CONNECTION ASSESSMENT & APPROVAL PROCESS

**Project: Excitation System Replacement for
Steephill Falls GS**

CAA ID: 2011-EX539

IESO EXPEDITED SYSTEM IMPACT ASSESSMENT – 2011-EX539

Figure 2- V-curve using Exponential saturation (GENSAE)

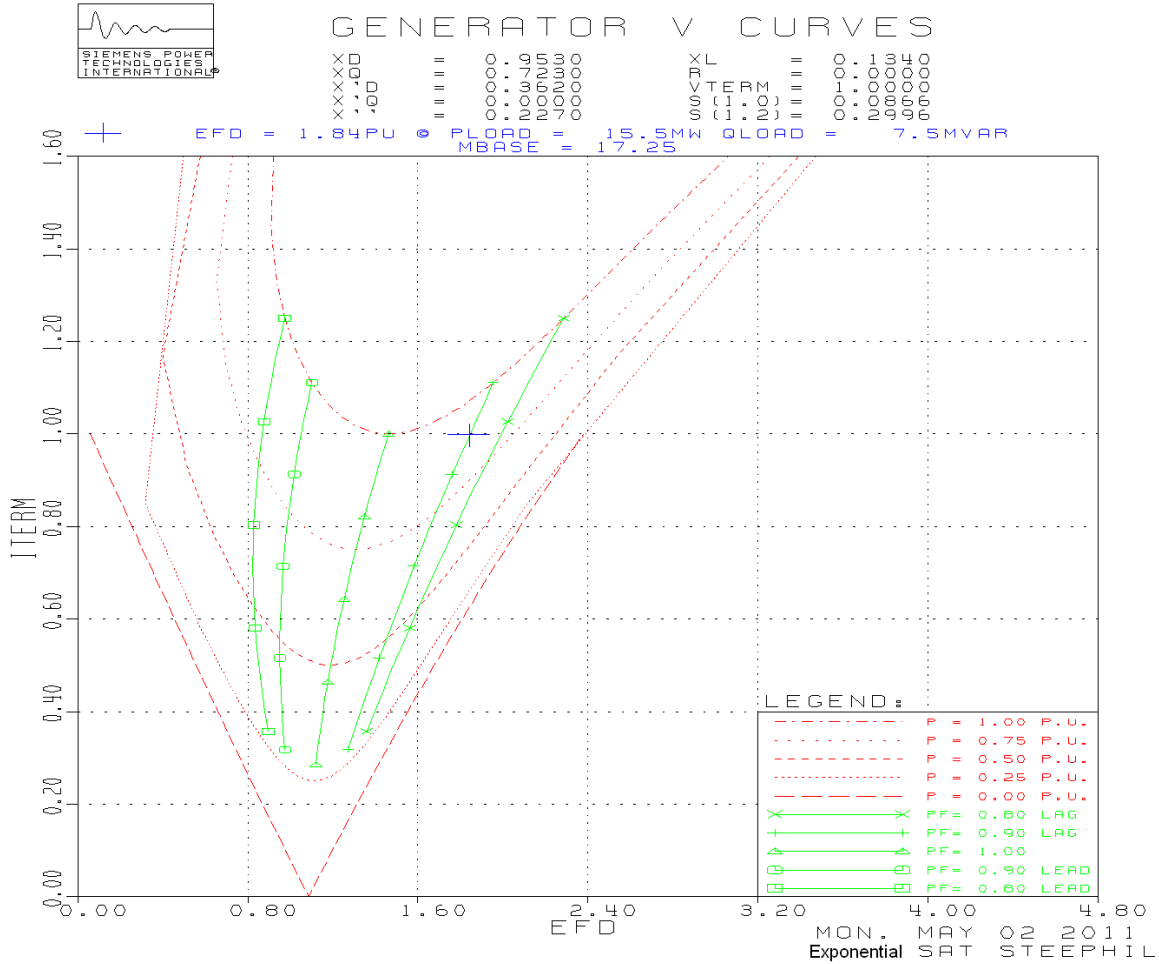
Verification of the generator model provided by the applicant has shown that the use of GENSAE model is more appropriate than the GENSAL model.

By plotting the V-curves using the PSSE V-curves module it is seen that the $E_{fd \text{ rated}}$ matches closely with the $E_{fd \text{ rated}}$ provided by the applicant along with the SIA application. Figure 1 and 2 shows the V-curves for GENSAL and GENSAE models.

Throughout the report GENSAE model is used for the purpose of the simulations.

Figure 3: Positive ceiling

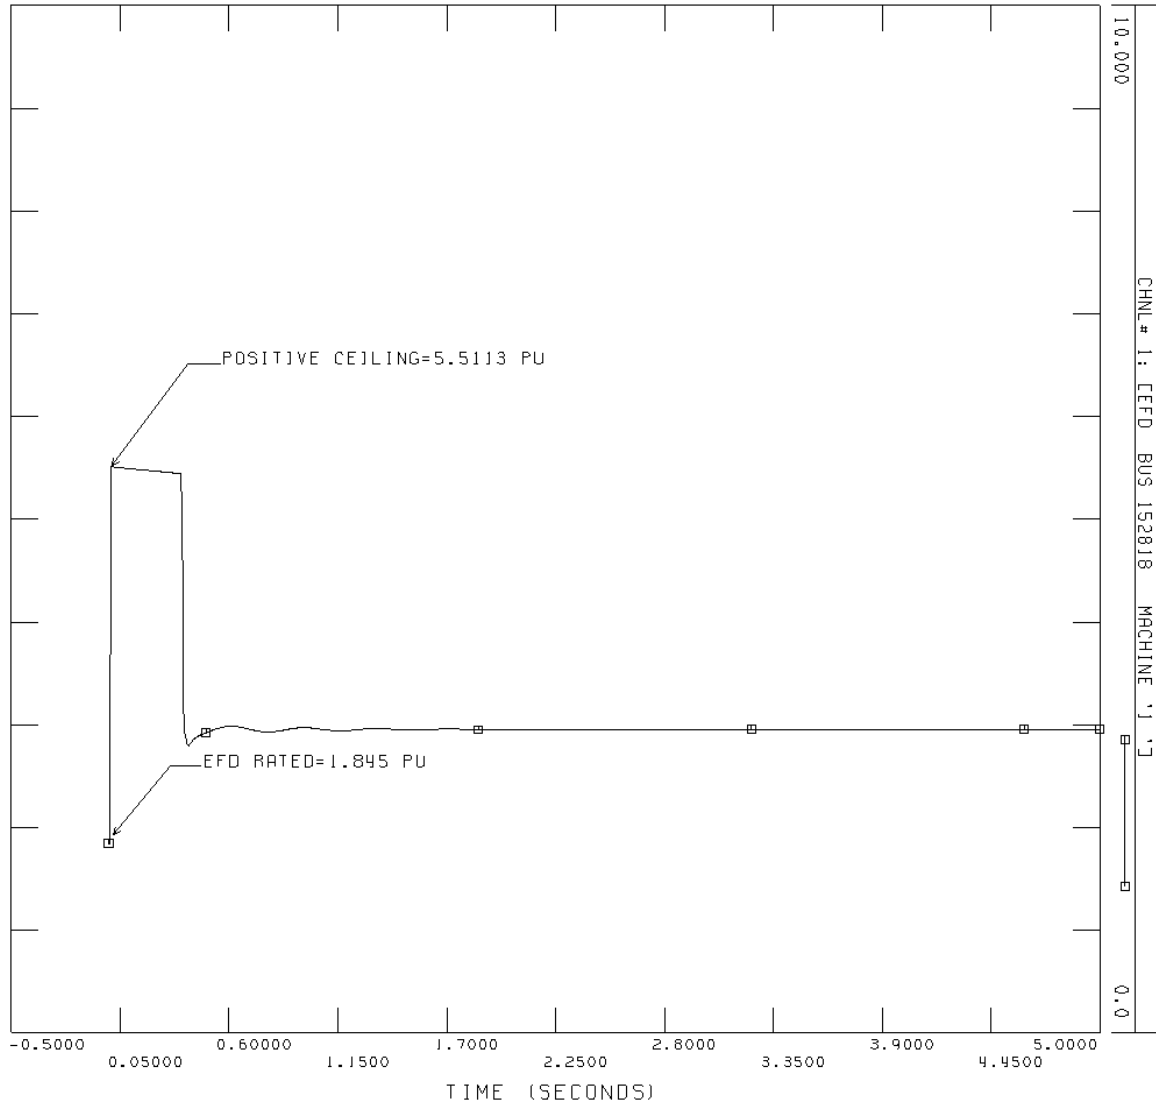
Response ratio test was performed to determine the positive ceiling limit for the excitation system. Market Rule requires that the excitation system should be able reach a positive ceiling of 200% of the $E_{fd \text{ rated}}$.

Required Positive ceiling= $2 \times E_{fd \text{ rated}} = 2 \times 1.845 = 3.69 \text{ p.u}$

Exciter positive ceiling response= 5.5113 p.u

Simulation shows that the excitation system positive ceiling response meets the Market rule requirement.

Figure 4: Negative ceiling

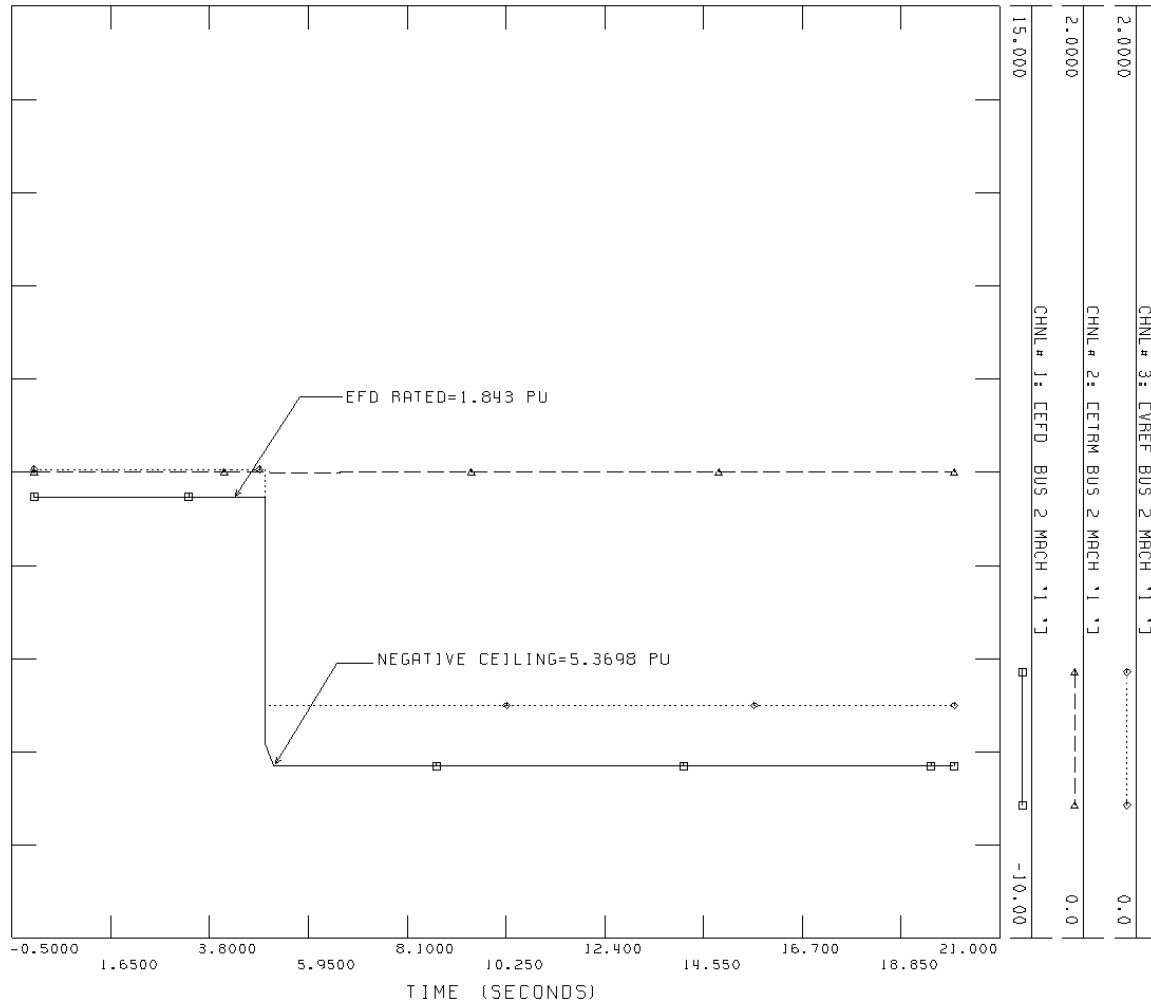
Market rules stipulate that excitation system for the synchronous generators should be able provide a negative ceiling of 140% of the $E_{fd\ rated}$. Response ratio test shows that the excitation system for Steephill Falls unit meets the negative ceiling requirement. Results of the simulation given below shows that excitation system negative ceiling limit meets the Market rule requirement.

Required negative ceiling= $-(E_{fd\ rated} \times 1.4) = -1.845 \times 1.4 = -2.583 \text{ p.u}$

Exciter negative ceiling response= -5.3698 p.u

Figure 5: Positive ceiling voltage response time

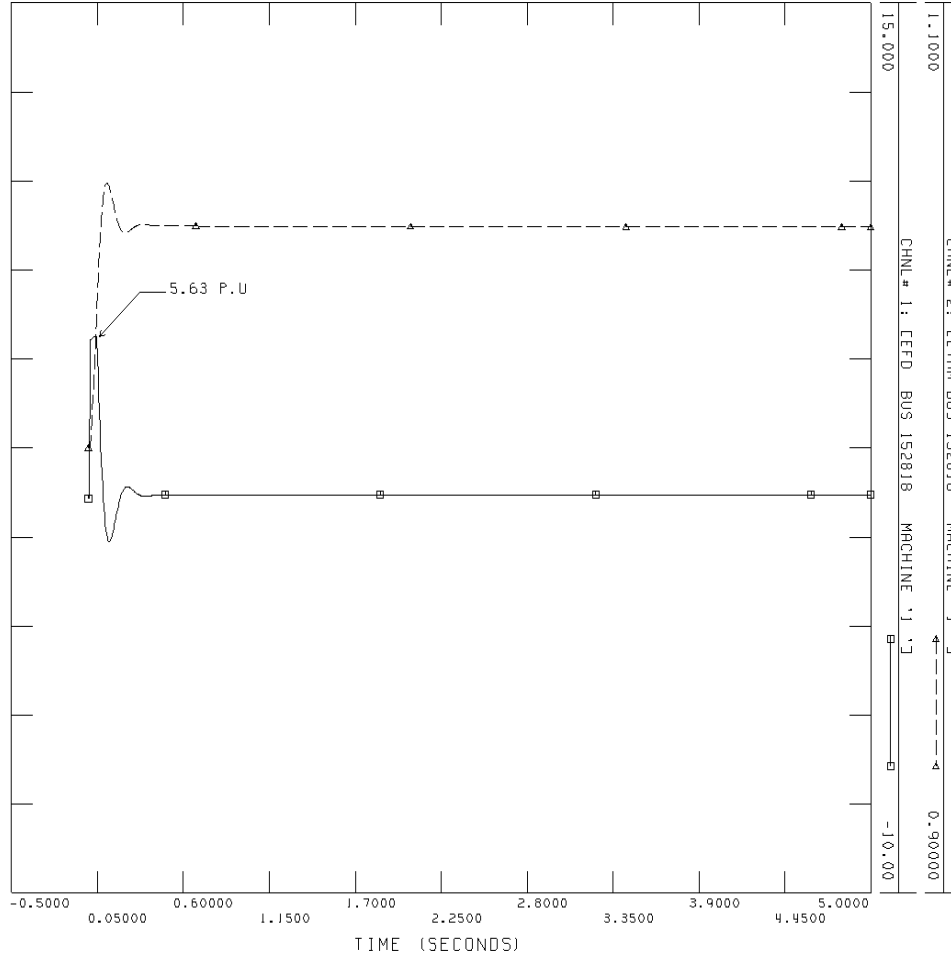
For positive ceiling a reference voltage step change of 5% was simulated to verify that the excitation system is capable of reaching $1.95 \times E_{fd \text{ rated}}$ within 50 ms.

$$RT_{OC_POS}=73.69\text{ ms}$$

$$\text{Required } E_{fd}\text{ (positive) ceiling} = 1.95 \times E_{fd\ rated} = 1.95 \times 1.845 = 3.6153\text{ p.u within } 71.64\text{ ms}$$

Plot for open circuit test (Figure 3) shows that excitation system reaches the Efd of 5.63 p.u in 29.2 milliseconds for a voltage reference step change of +5 %. It is concluded that excitation system is able to provide the required positive ceiling within the specified time.

Figure 6: Negative ceiling voltage response time

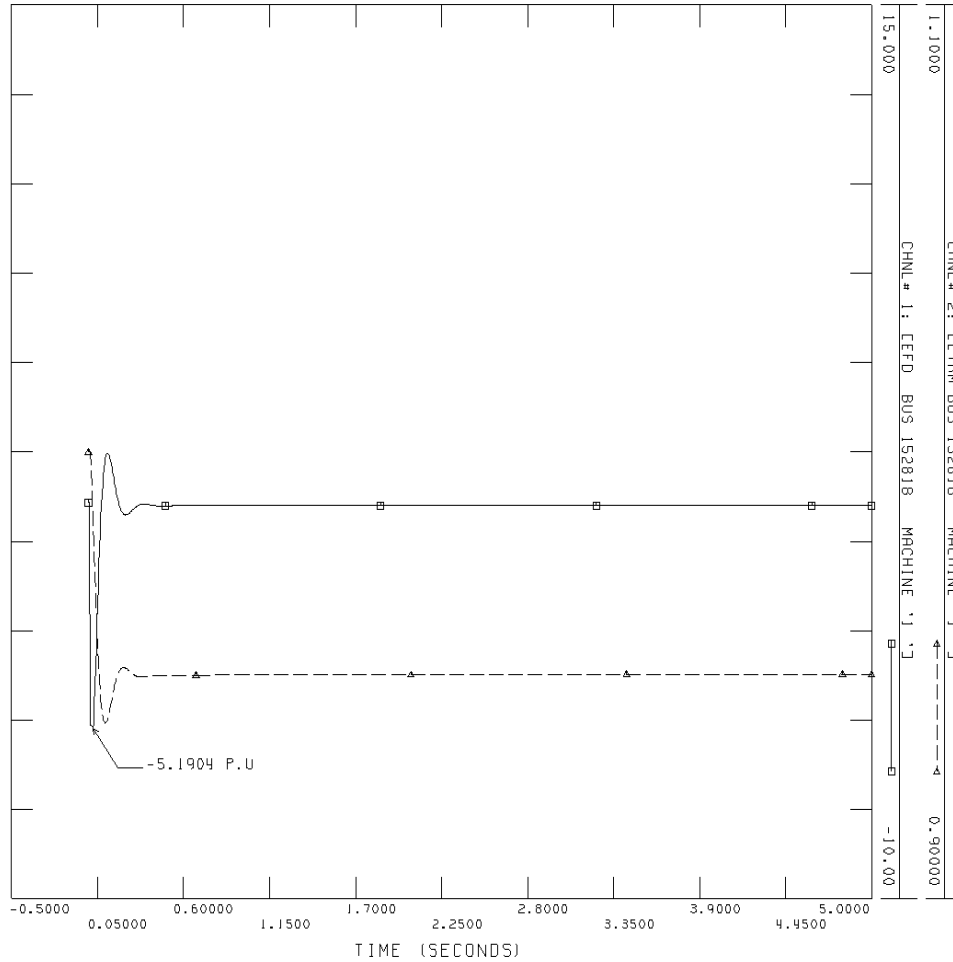
Starting from $E_{fd\ rated}$, Excitation system should be able to reach a negative ceiling of 128% within 50 ms for a voltage reference step change of -5%. Test results are translated to open circuit voltage response time by using the equation given below.

$RT_{OC_NEG}=39.74\ ms$

Required Efd (negative) ceiling= $-1.28 \times E_{fd\ rated}=- 2.361\ p.u$

Figure 4 depicts that excitation system reaches a negative ceiling of -5.1904 p.u in 20.8 milli-secs for voltage reference step change of -5%. It is concluded that excitation system meets the voltage response time requirement for negative ceiling specified in the Market rules.

Figure 7: Exciter response with high field current

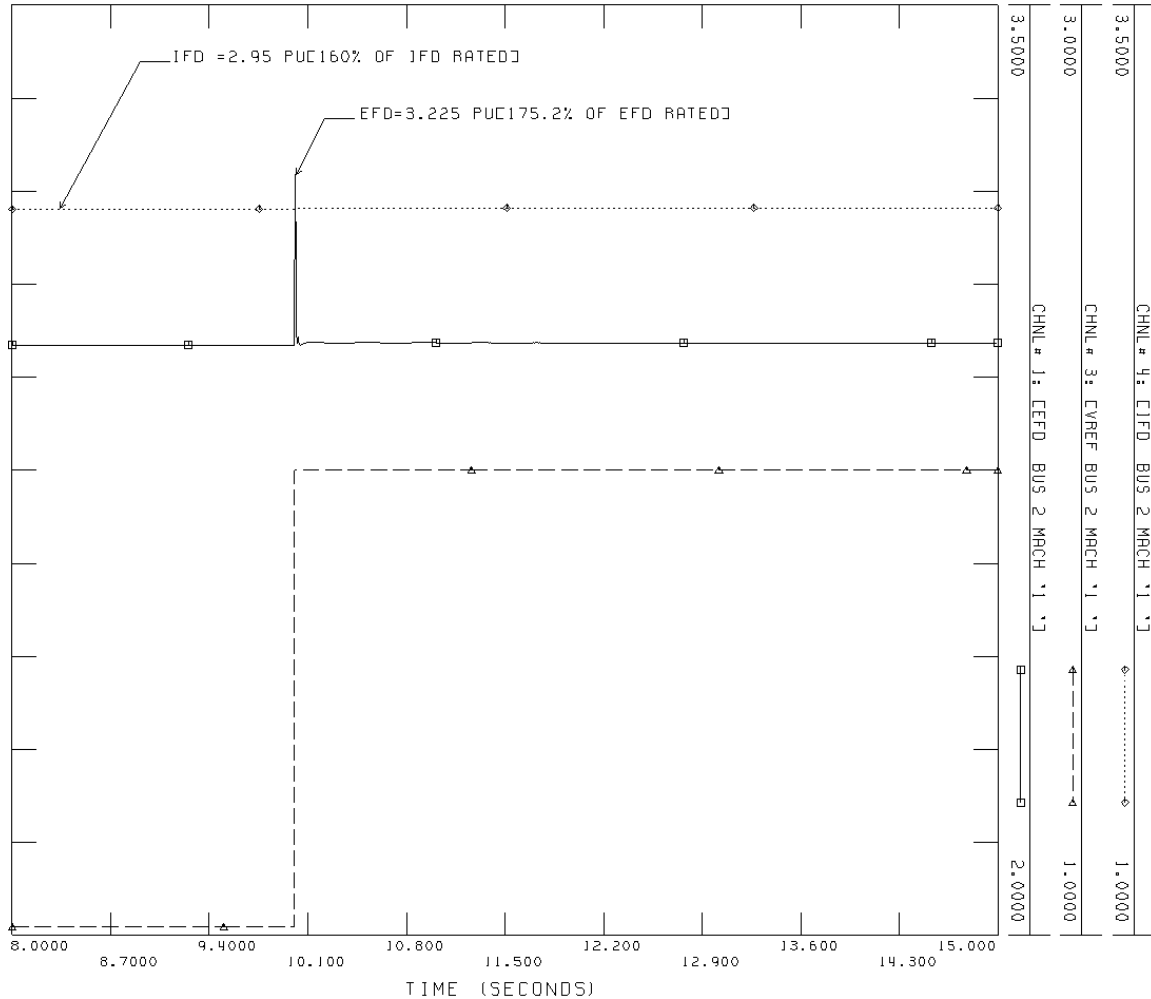
Market rules requires that, at rated terminal voltage the excitation system should be able to reach the positive ceiling of 170% of $E_{fd\ rated}$ when the field current is 160% of $I_{fd\ rated}$.

The excitation system is required to have a positive ceiling of 3.136 p.u. Test results depicted in Figure 5 shows that the exciter is able to produce E_{fd} up to 3.225 p.u (175.2% of $I_{fd\ rated}$). Hence, the excitation system meets this requirement.

Fig. 3 - Steephill Falls Unit- Rotor angle comparison for a 3 phase fault¹

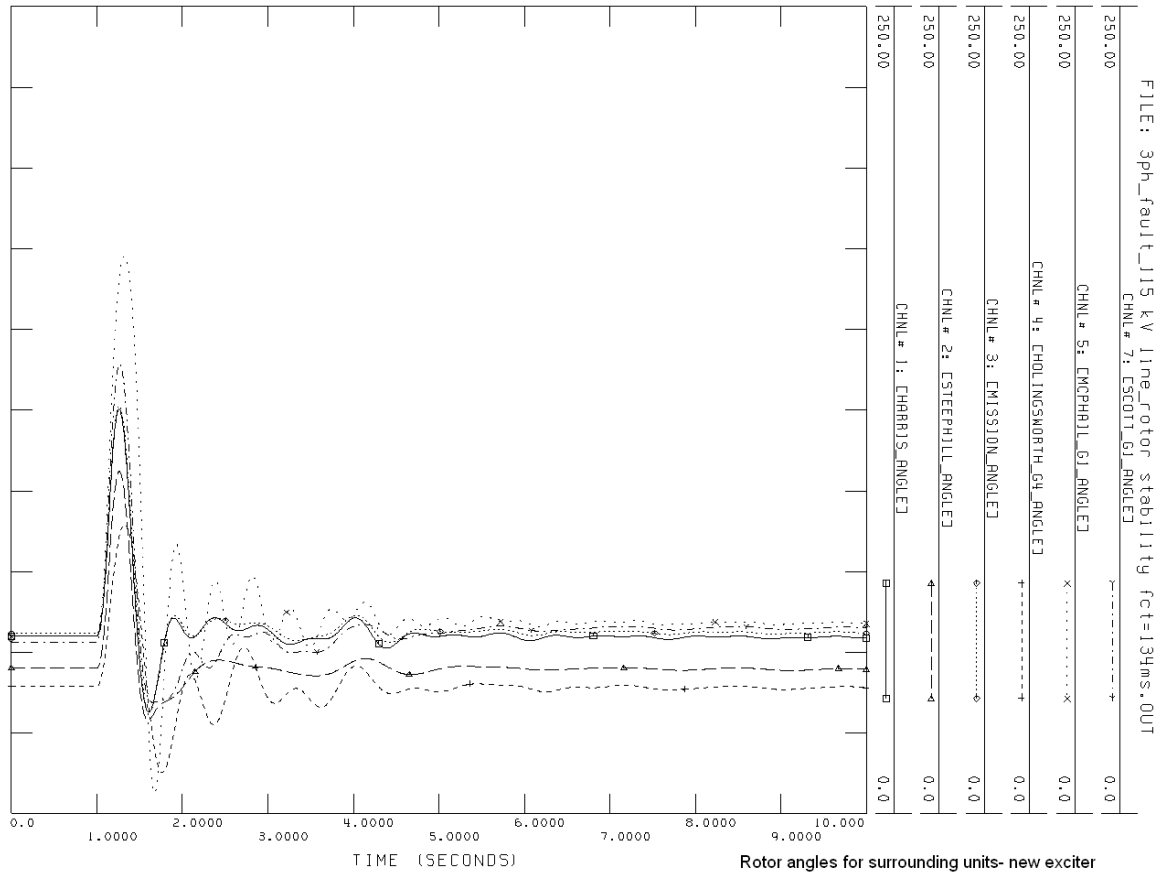
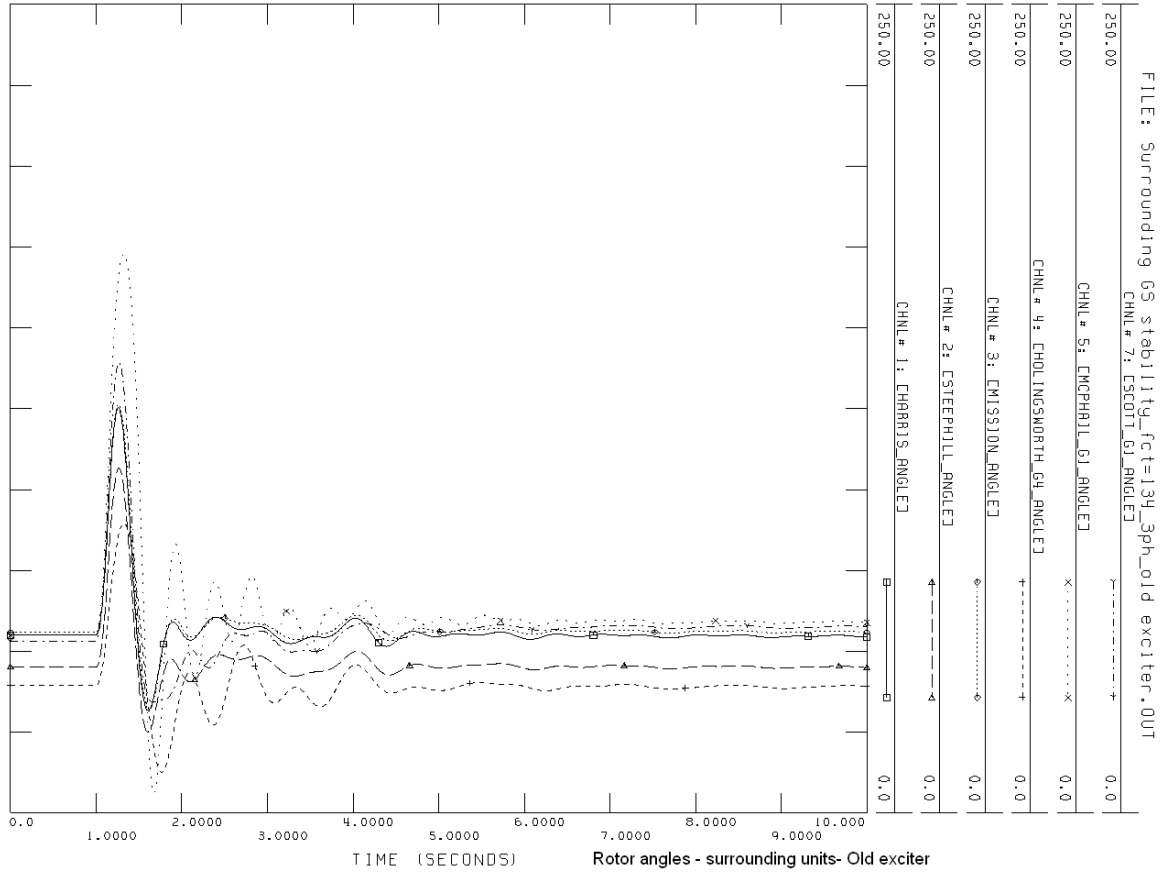
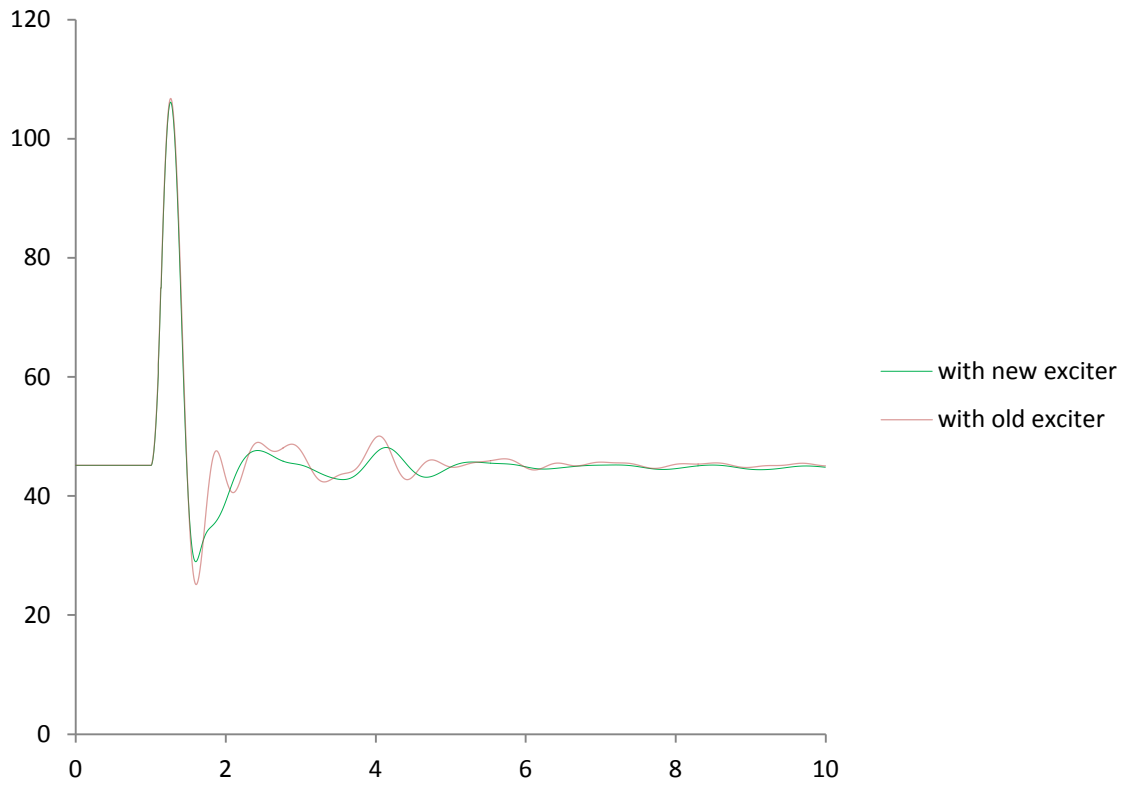
Rotor angle stability of the nearby generators is checked for a system fault which does not remove the Steephills GS unit by configuration. A three phase fault simulated on the 115 kV circuit No.2 from Watson TS to Anjigami TS with the fault clearing time of 134 milli-secs confirms that the Steephill Falls unit and the units at the surrounding generating stations remain stable.
